City of Phoenix Office of the City Engineer Design and Construction Procurement

HAPPY VALLEY ROAD: 67TH AVENUE TO 35TH AVENUE ROADWAY IMPROVEMENTS DESIGN-BID-BUILD

> PROJECT NO. ST85100437 FEDERAL AID NO. PHX-0(363)D ADOT TRACS NO. T0239 01C

ADDENDUM NO. 2

DR: RJN | DES: ASF | CK: TJC | DWG. NO. G-2.03 | CK: G-2.

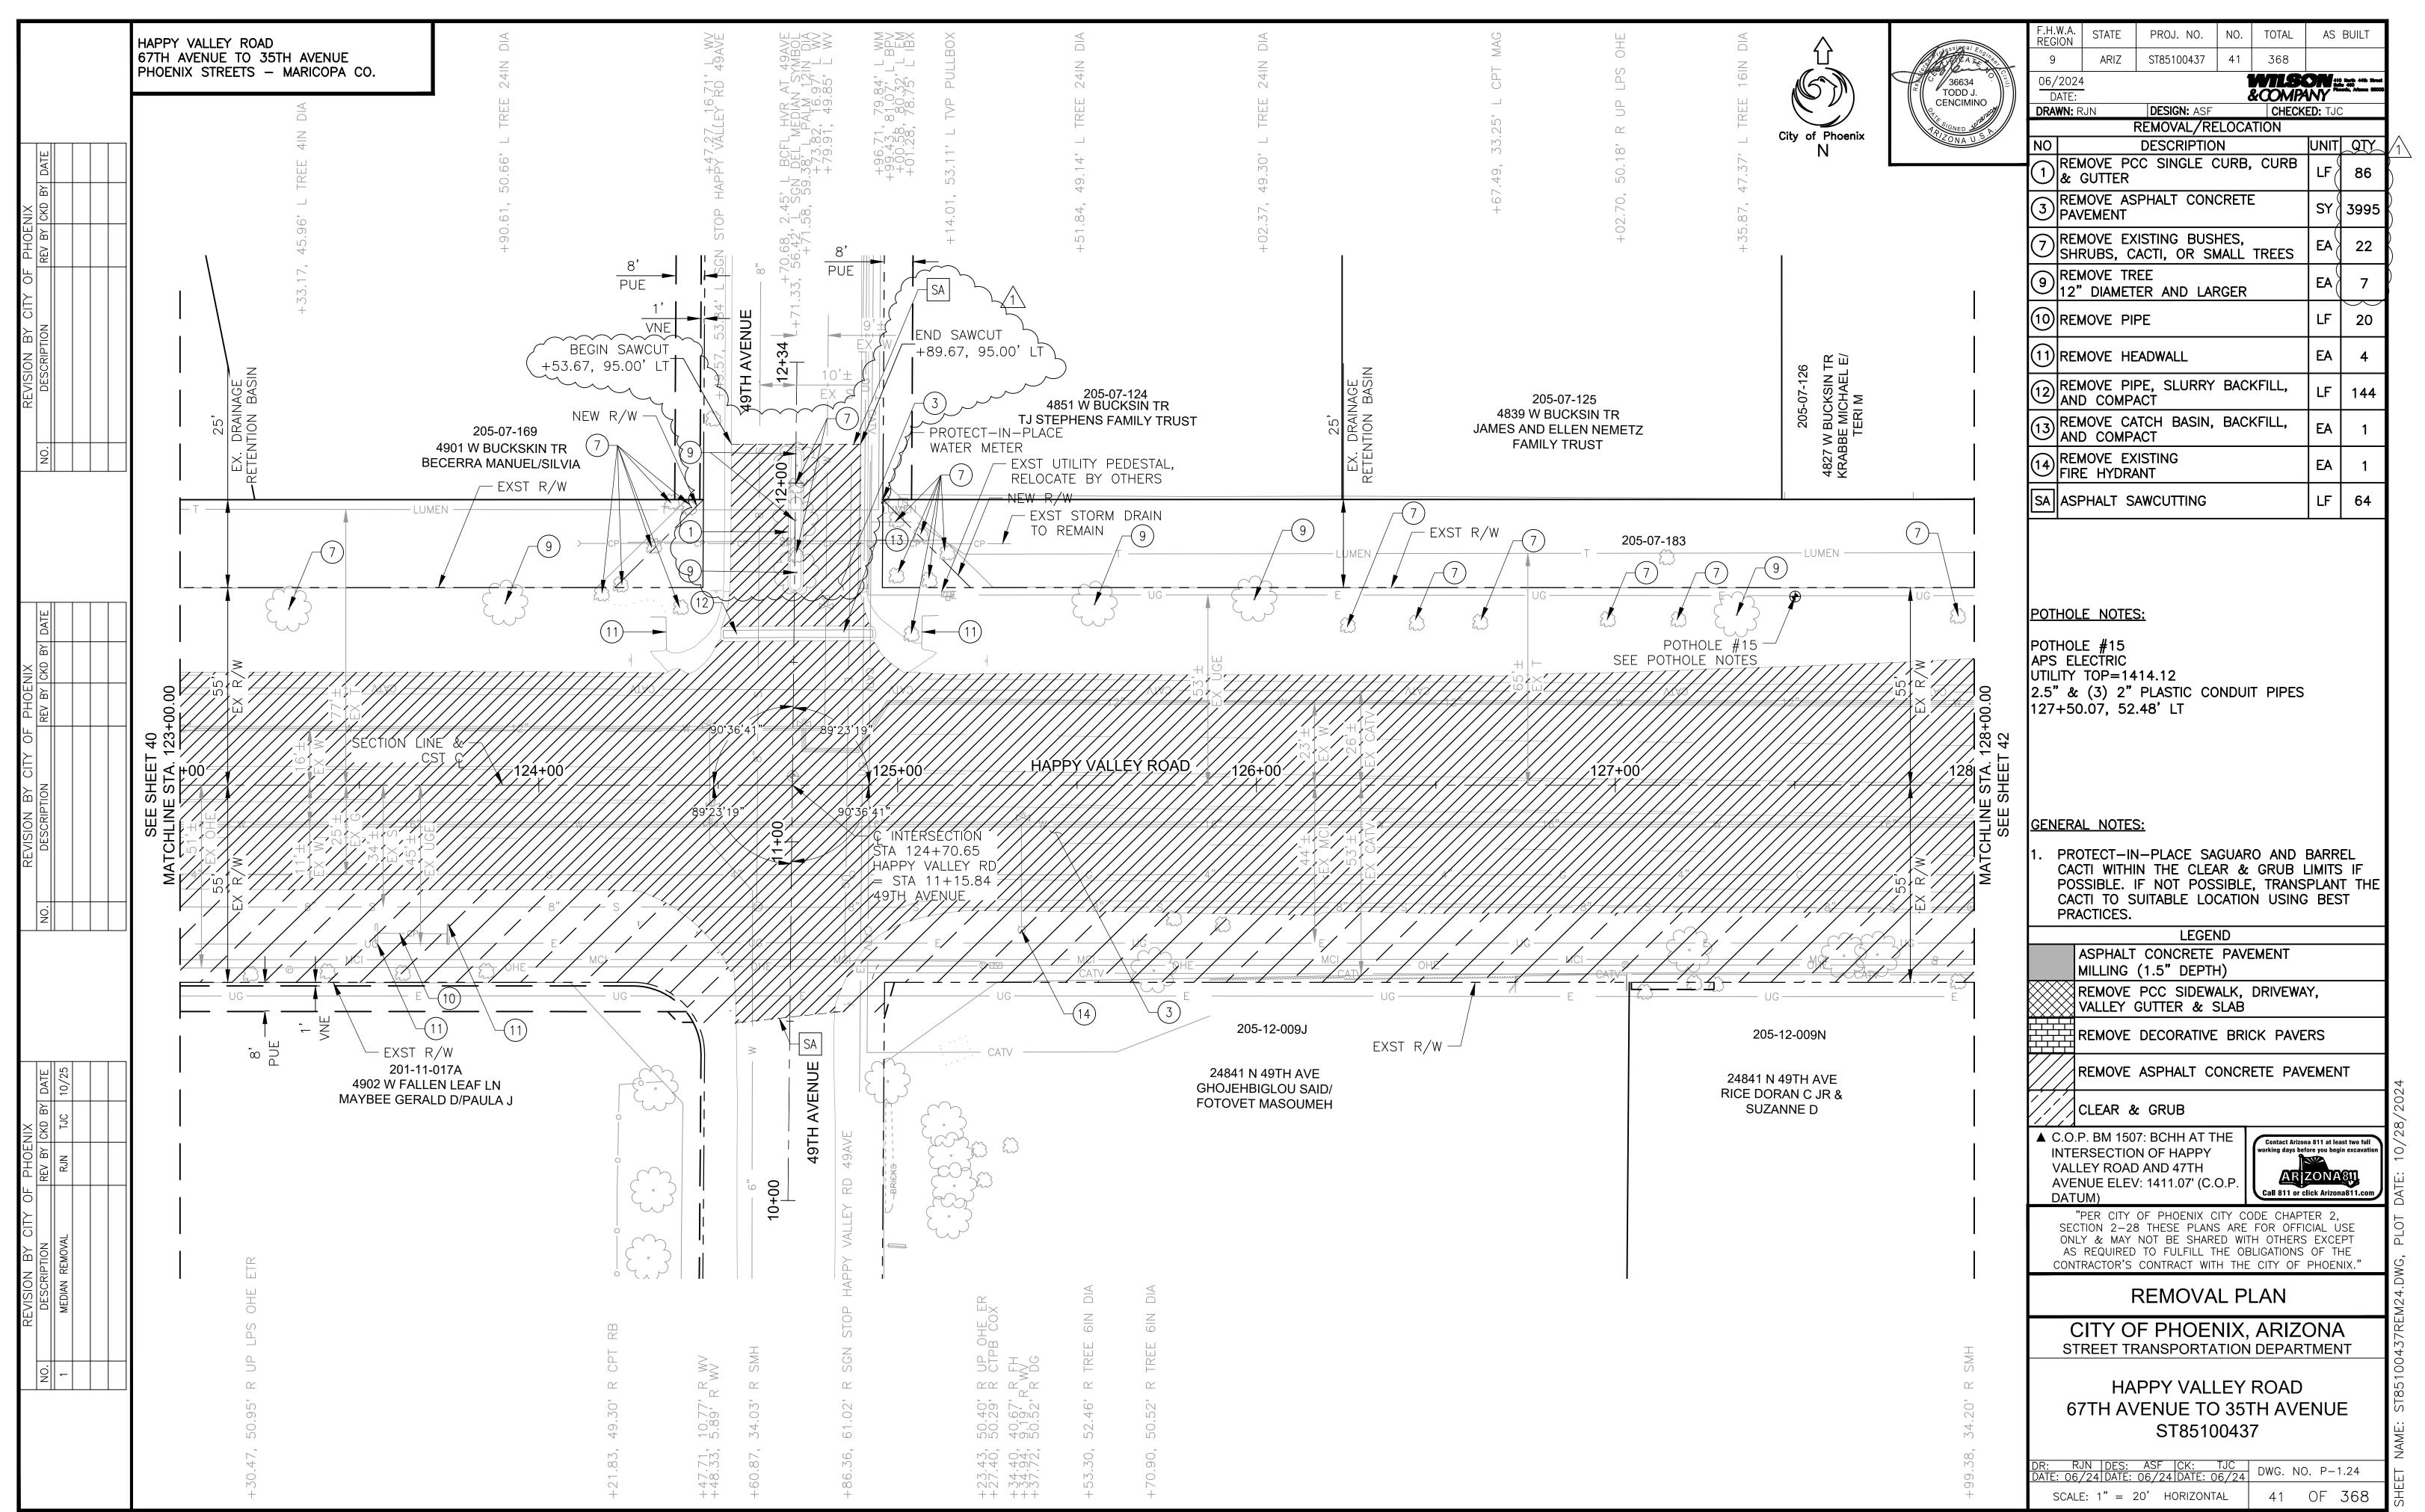
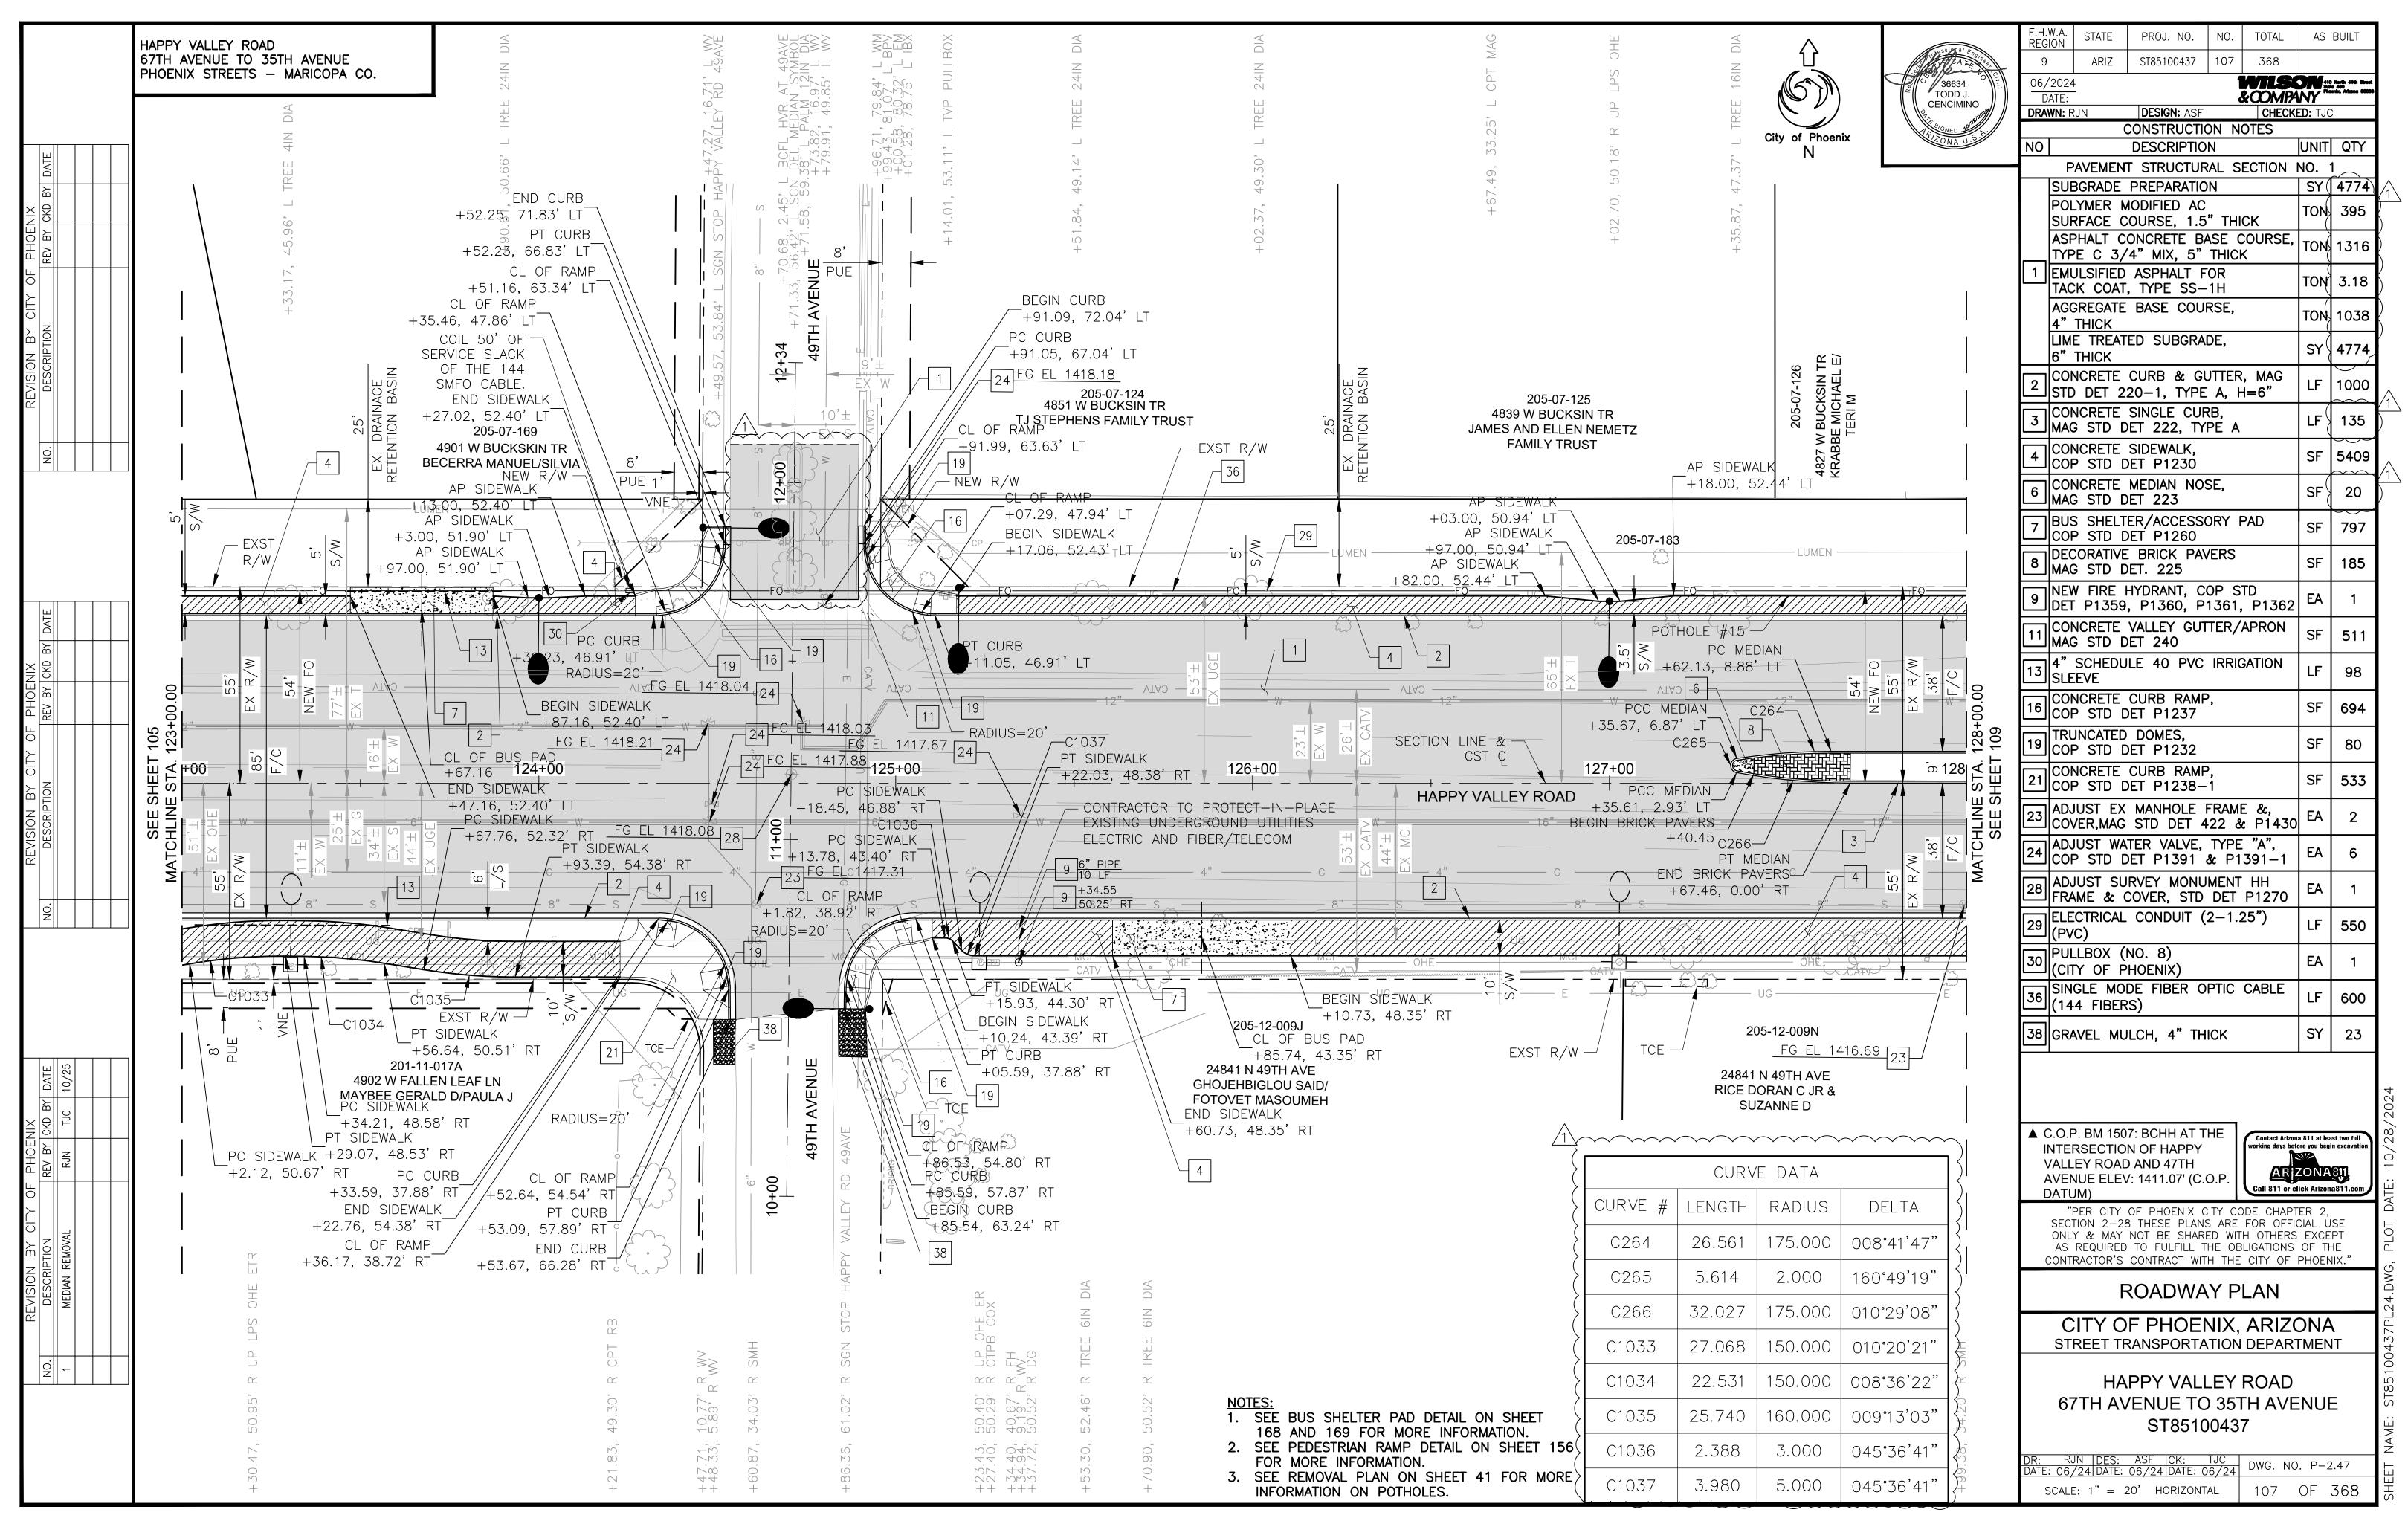
- Q21. Clarify what electrical materials are being provided and installed by the City. The special provisions, pay items and the traffic signal plans and details (specifically note 3) contradict each other.
- A21. Plans: Note 3 on Wilson & Company's traffic signal sheets reflects a non-federal aid note to contractors. See attached revised plans. Replace Note 3 on sheets 320, 328, 336, 344, and 346 with the following:
 - 3. WORK TO BE PERFORMED BY CITY OF PHOENIX SIGNAL CREWS
 Traffic Signal representative shall approve marked layout of ADA ramps, junction boxes
 and foundation locations prior to excavation, prep contractor furnished controller
 cabinets and internal equipment (contractor to pick up and install controller cabinet),
 inspect and approve all traffic signal equipment installed by contractor and terminate,
 test, and activate all field wiring into controller cabinet(s).
